FINAL DRAINAGE LETTER FOR LOT 3 OF CLAREMONT BUSINESS PARK 2 FILING NO. 1

Project #44-037
PCD – SP 20-000

RE: Drainage Letter for Lot 3 of Claremont Business Park 2 Filing No. 1

CLAREMONT BUSINESS PARK 2 FIL. NO.1			
LOT 3			
PROJECT NO. 44-037A	FILE: \\dwg\Eng Exhibits\44037-FDRM-Lot 3.dwg	DATE: 02-15-2021	
DESIGNED BY: ET	SCALE: HORIZ: 1"=30'		
DRAWN BY: GW	VERT: N/A		
CHECKED BY: VAS		SHEET 1 OF 1	FDM01

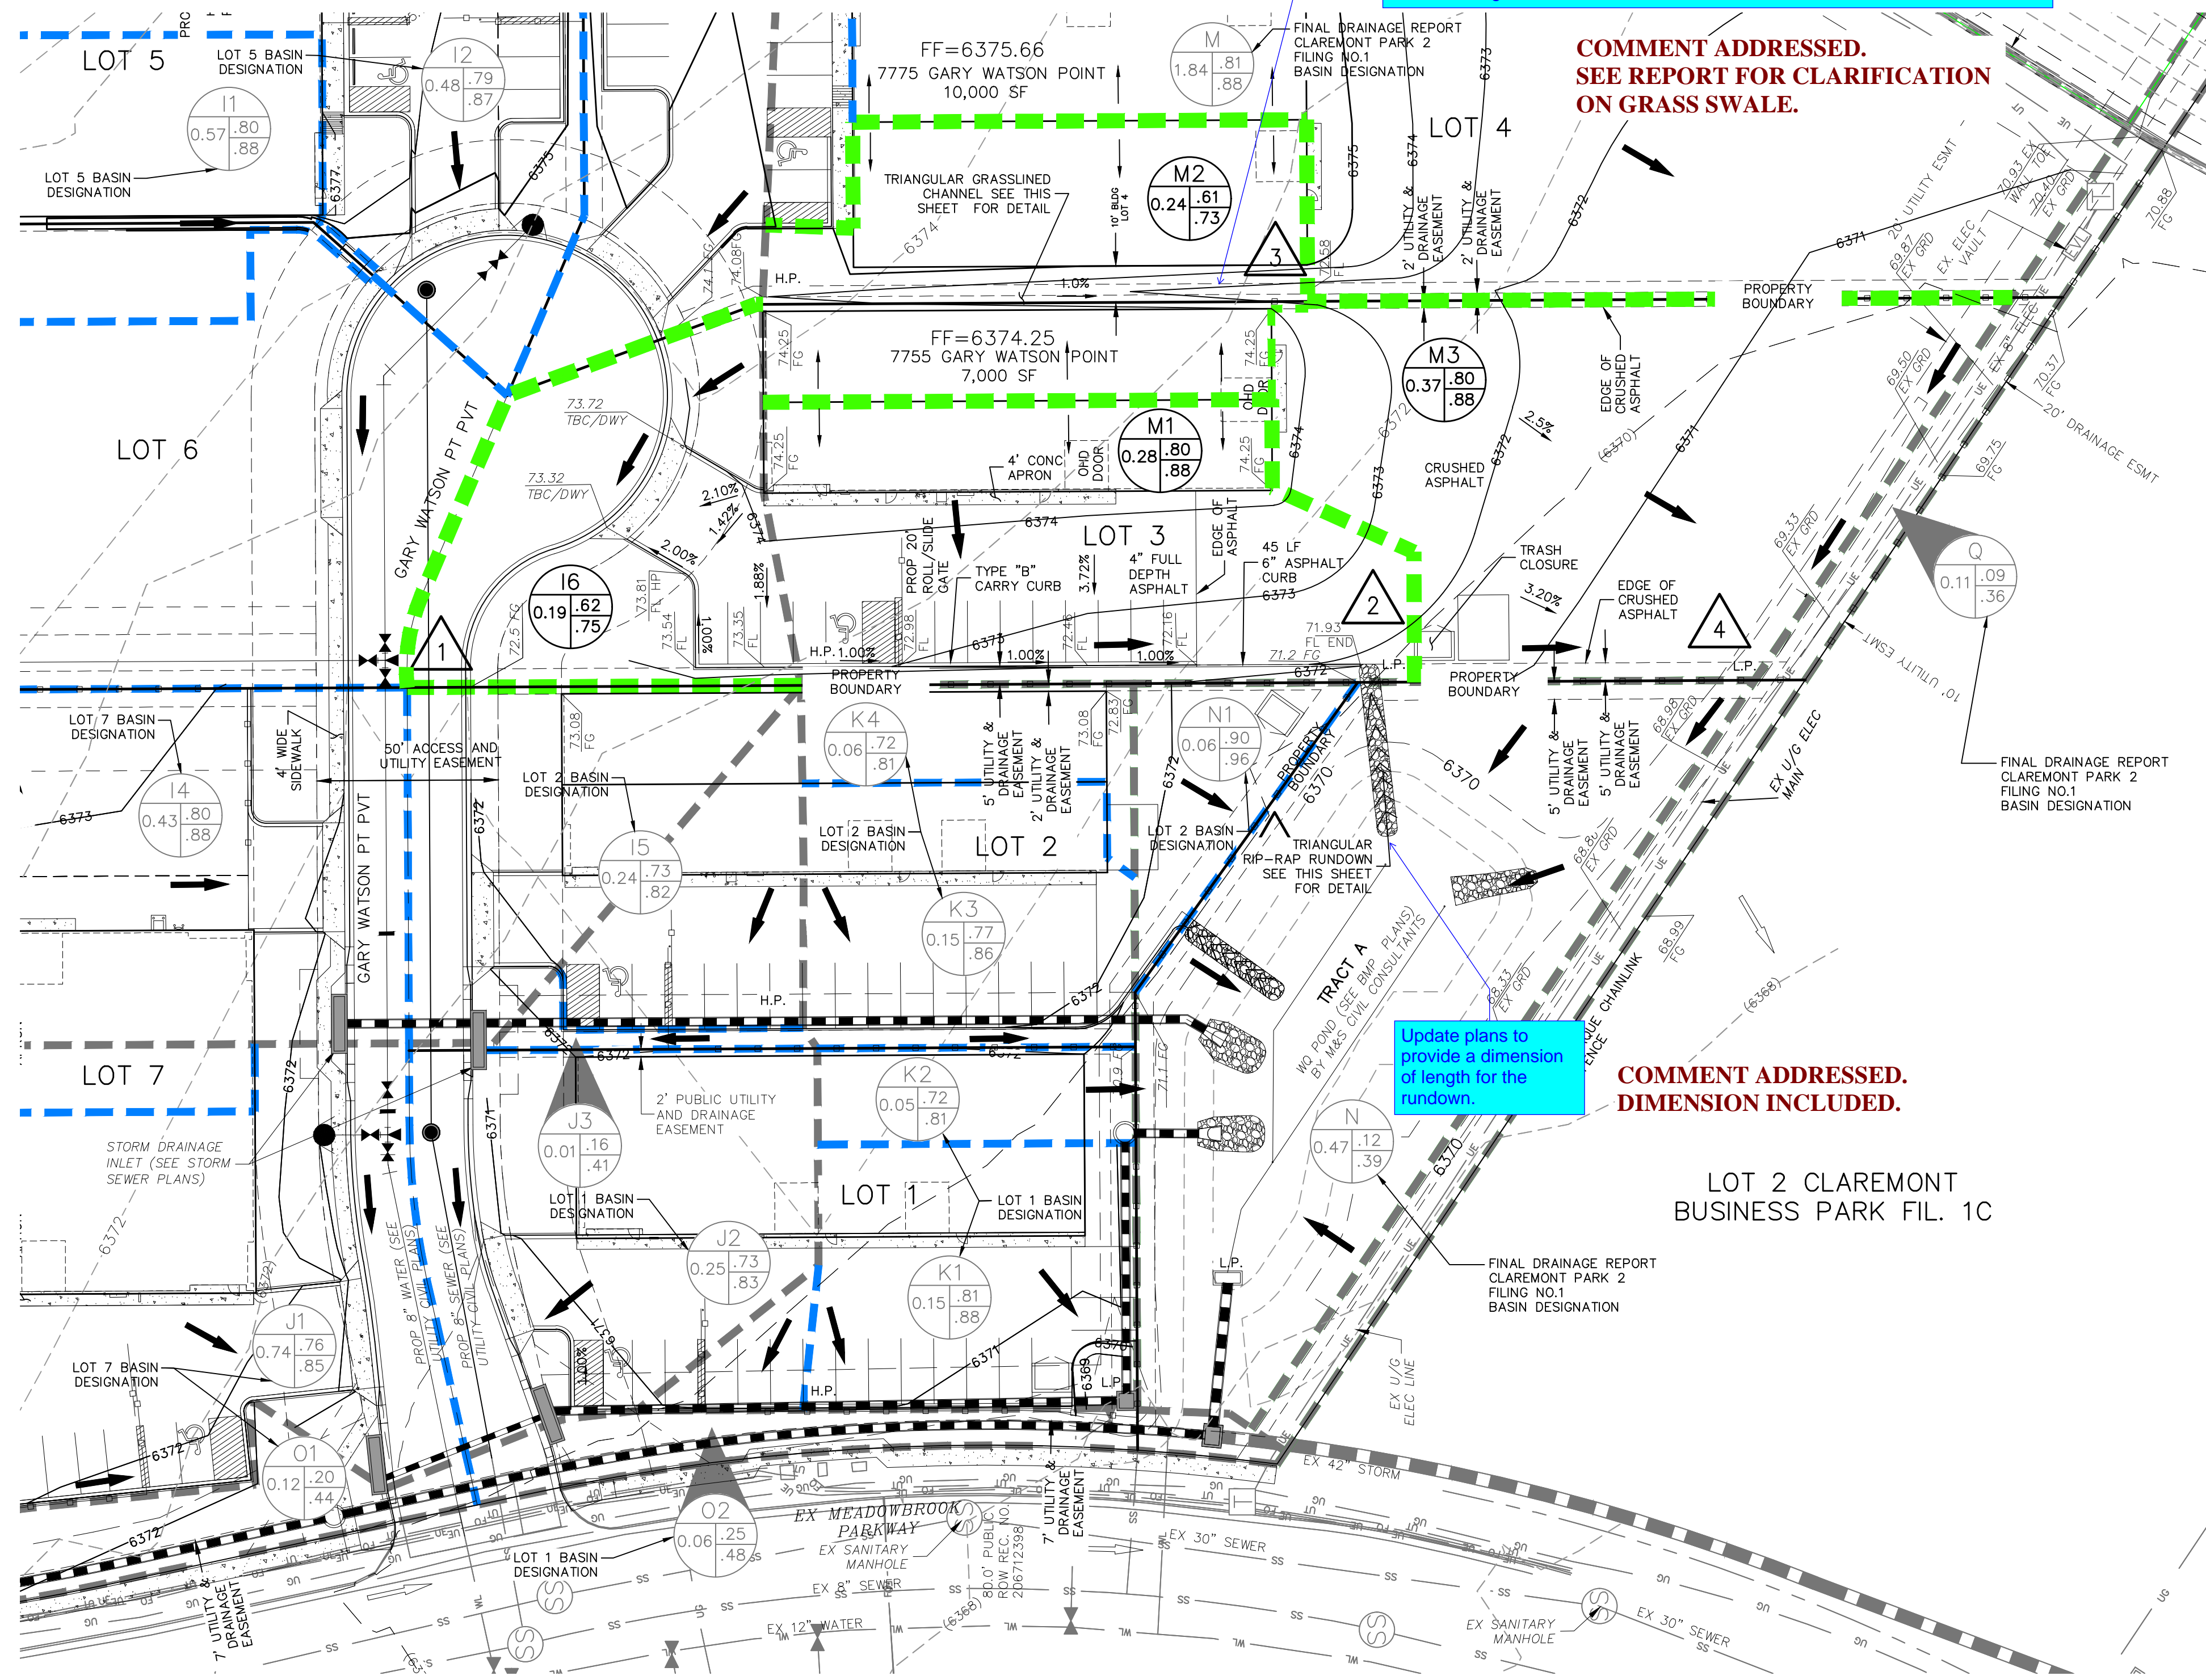
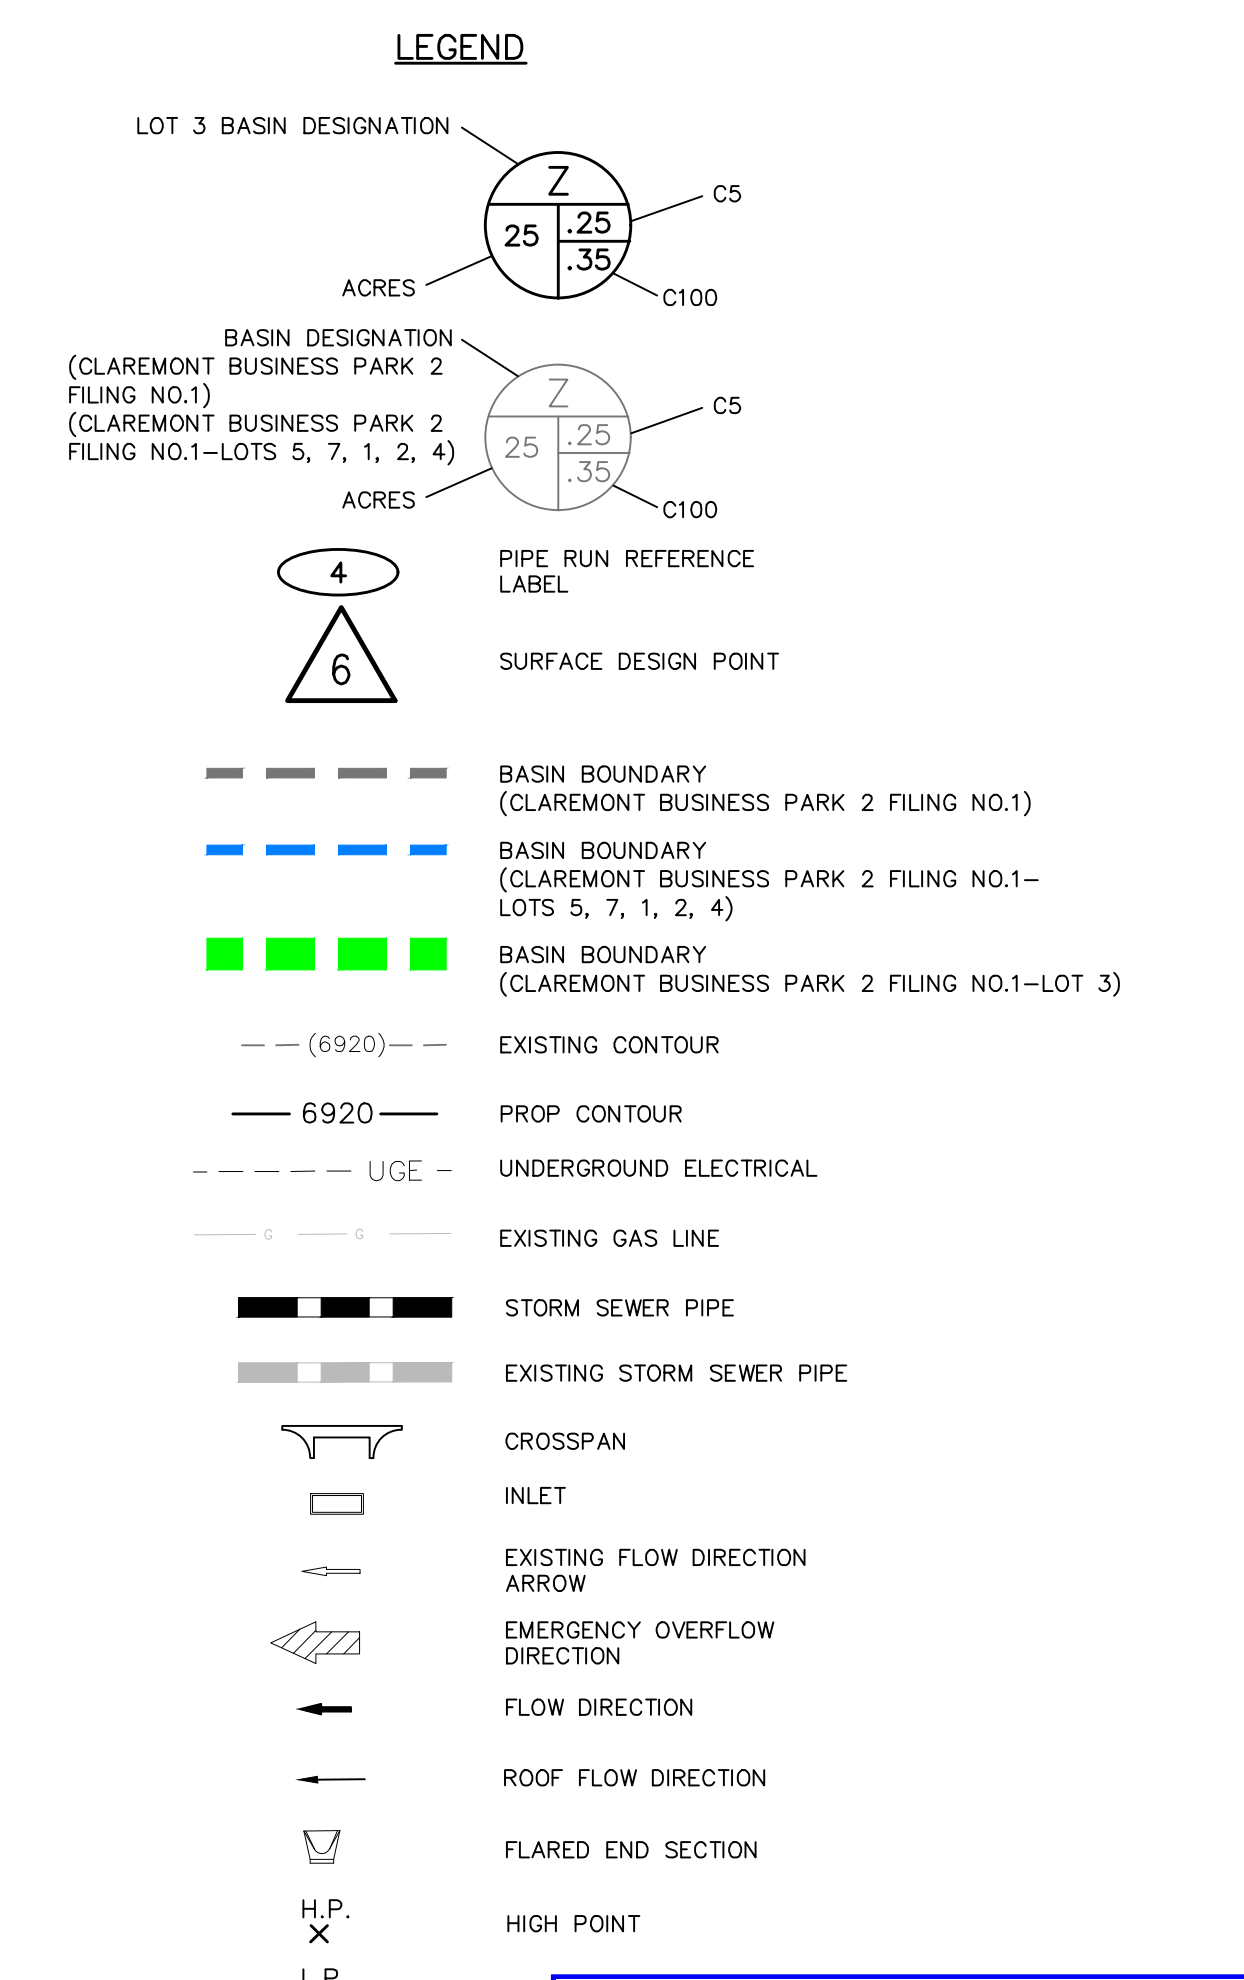
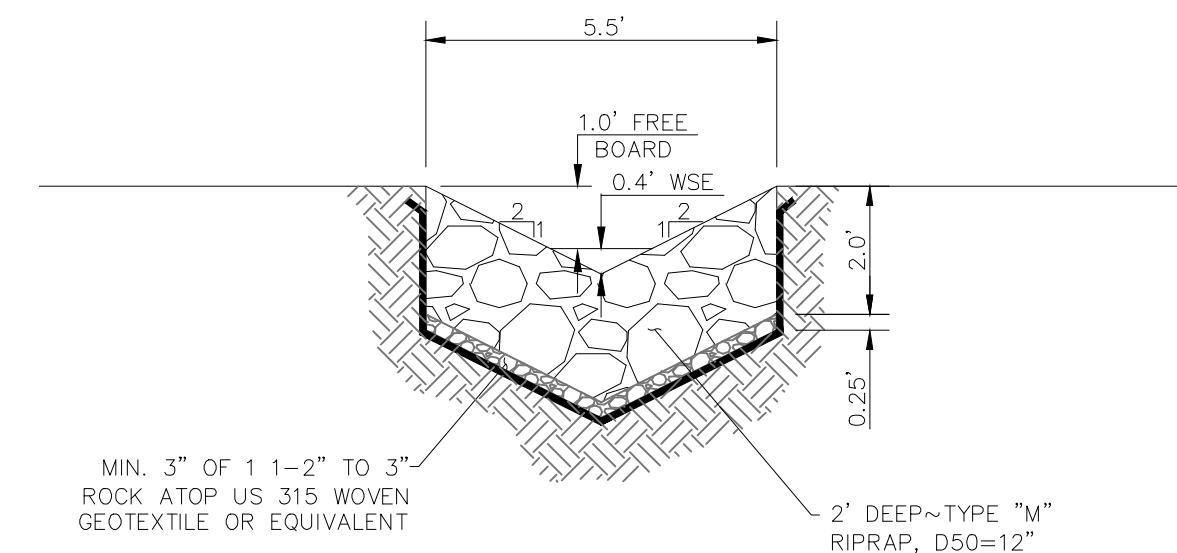
This is meant to be a concrete channel per SF-2014 drainage report. Revise to be in compliance with original report, or redesign grass swale to have water levels within drainage easement.

Update plans to
provide a dimension
of length for the
rundown.

Note: drainage easement does not contain entire flow of DP3. Update channel/swale to fit within drainage easement.

COMMENT ADDRESSED.
SEE REPORT FOR CLARIFICATION
ON GRASS SWALE.

COMMENT ADDRESSED.
DIMENSION INCLUDED.

COMMENT ADDRESSED.
SEE REPORT FOR CLARIFICATION
ON GRASS SWALE. FLOW CONTAINED
WITHIN EASEMENT.
